SUBMIT IN TRIPLICATE - Other instructions on reverse side    1. Type of Well	7. If Unit or CA/Agreement, Name and/or No.
Oil Well X Gas Well Other  2. Name of Operator	8. Well Name and No.
	Carracas 23A 10
3a. Address  2198 Bloomfield Highway, Farmington, NM 87401  4 Location of Well (Footage, Sec. T. R. M. or Survey Description)	9. API Well No. 30-039-27549 10. Field and Pool, or Exploratory Area Basin Fruitland Coal  11. County or Parish, State Rio Arriba NM
12. CHECK APPROPRIATE BOX(ES) TO INDICATE NATURE OF NOTICE, F	REPORT, OR OTHER DATA
TYPE OF SUBMISSION TYPE OF ACT	ION
Alter Casing Fracture Treat Reck  Subsequent Report Casing Repair New Construction Recc  Temporal Abandonment Notice Reck  Change Plans Plug and Abandon Temporal Reck  Tem	water Shut-Off  mation  Well Integrity  omplete  orarily Abandon  or Disposal

Energen Resources plans to make the following changes to the Carracas 23A #10 well:

## 2005 JUN 22 6M 8 WELL LOCATION AND ACREAGE DEDICATION PLAT

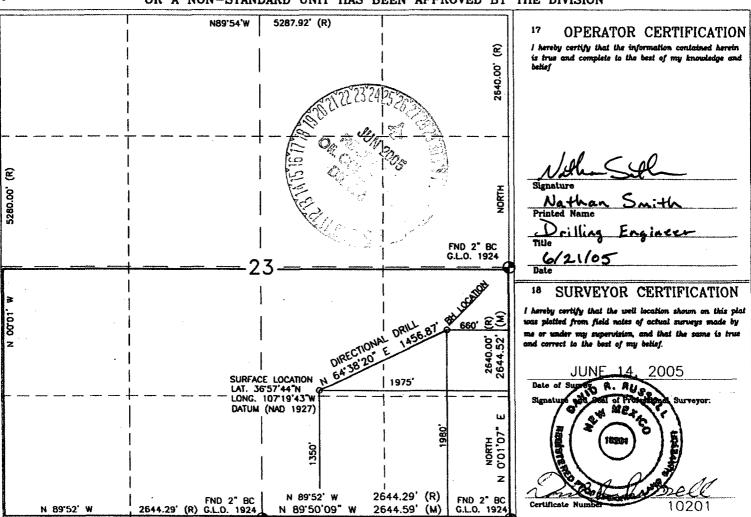
- \* Change from a vertical drill plan to a horizontal drill plan as indicated on the attached C-102 and directional survey.
- \* Change the setting depth of the 7" intermediate string from 3742'(TVD) to 3792'(TVD), 4050'(MD) and cement with 545 sks of lead followed by 125 sks of tail (1223 cu.ft.)
- \* Change the 5-1/2" production liner to 4-1/2", 11.6#, J-55 LT&C production liner, and set to 3792' (TVD), 5112' (MD).
